Technical Service Bulletin

SUBJECT:		No: TSB-22-23-002	
MAINTENANCE PROCEDURE IMPROVEMENT FOR CVT – SERVICE MANUAL REVISION		DATE: April 2022	
		MODEL: See below	
CIRCULATE TO:	<input type="checkbox"/> GENERAL MANAGER	<input checked="" type="checkbox"/> PARTS MANAGER	<input checked="" type="checkbox"/> TECHNICIAN
<input checked="" type="checkbox"/> SERVICE ADVISOR	<input checked="" type="checkbox"/> SERVICE MANAGER	<input checked="" type="checkbox"/> WARRANTY PROCESSOR	<input type="checkbox"/> SALES MANAGER

This TSB updates the Maintenance Procedure section, in the Automatic Transmission portion of the affected Service Manual.

LUBRICANTS

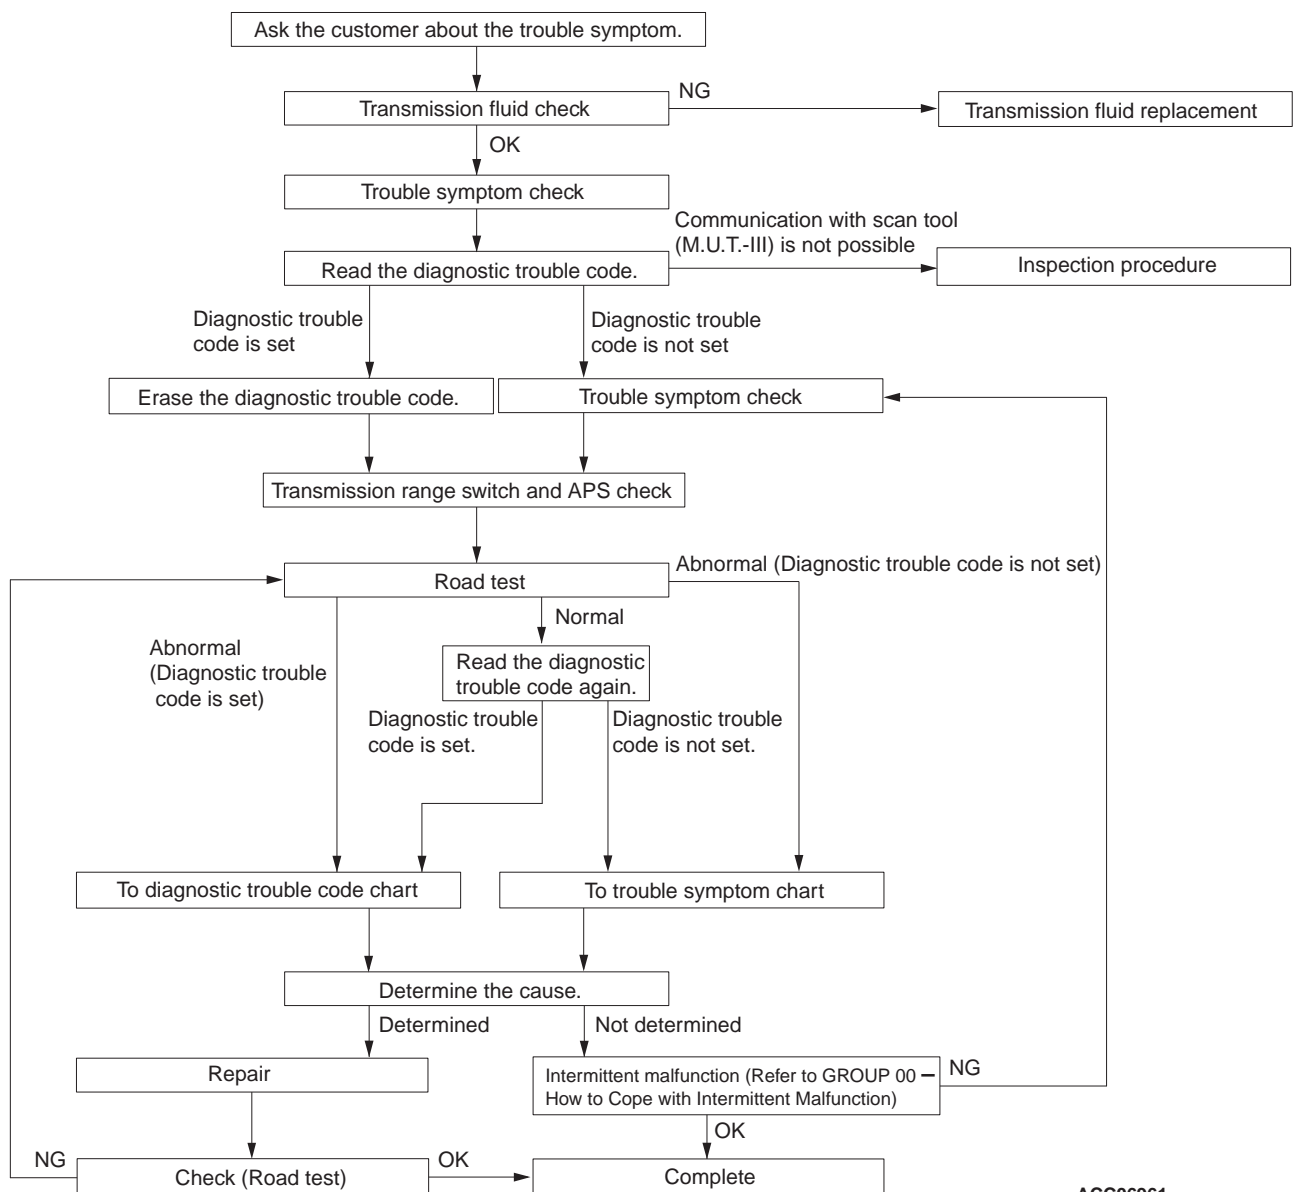
Item	Brand name	Capacity dm ³ (qt)
Transmission fluid	MITSUBISHI MOTORS GENUINE CVTF-J4	7.0 (7.4)
Cleaning the transmission case when CVT belt is inspected	Parts cleaner (MITSUBISHI MOTORS GENUINE Part No. MZ100387) or equivalent	As required

<Added>

STEP 4. CVT belt inspection.

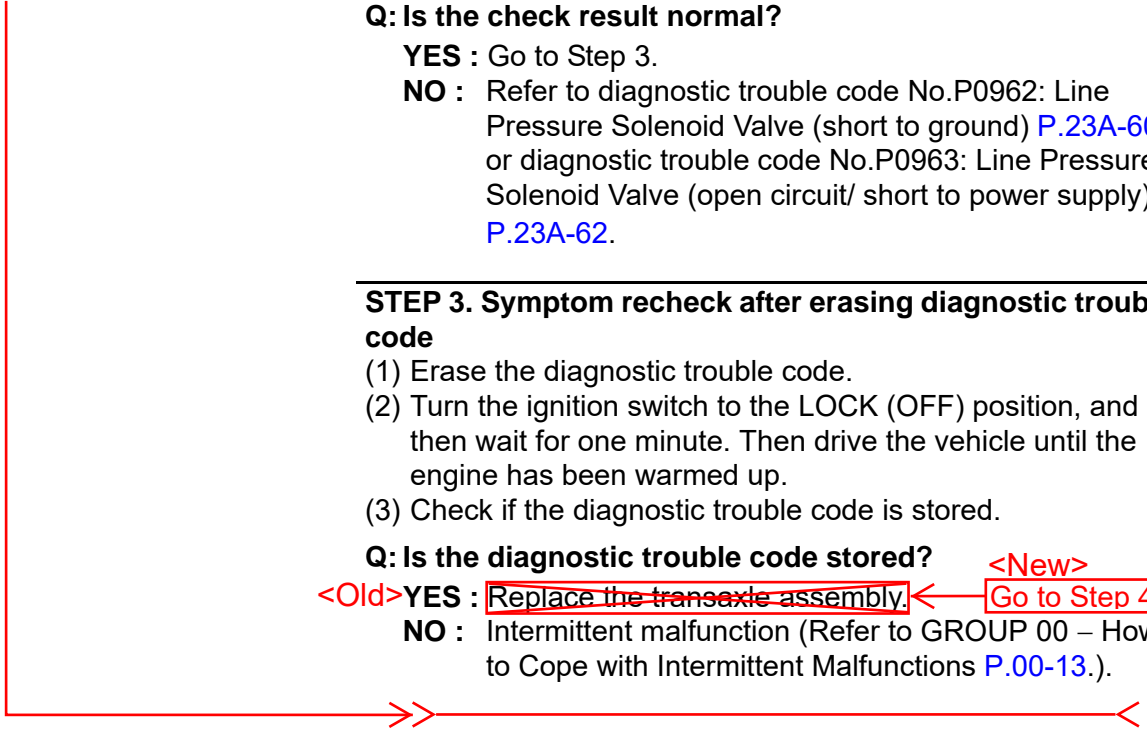
- <Old> YES** : ~~Replace the transaxle assembly.~~ **<New> Go to Step 4.**
- NO** : Intermittent malfunction (Refer to GROUP 00 – How to Cope with Intermittent Malfunctions [P.00-13](#)).

<Added>

Check the appearance of the CVT belt.
(Refer to On-vehicle Service – CVT Belt Inspection)

- YES** : Replace the valve body assembly.
- NO** : Replace the transaxle assembly.

CVT BELT INSPECTION

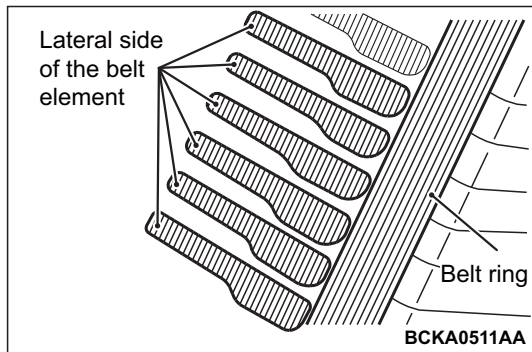
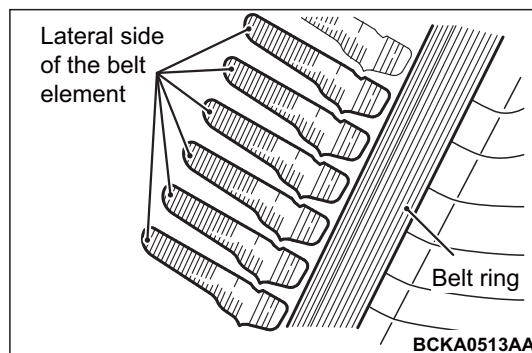
Use special tool bore scope (MQ600069), confirm that the lateral side of the belt element illustrated in the figure is not damaged.

The CVT belt is good if the lateral side of the belt element is not damaged, and the lines are regular.

The CVT belt is bad if the lateral side of the belt element is damaged, and the lines are worn out.
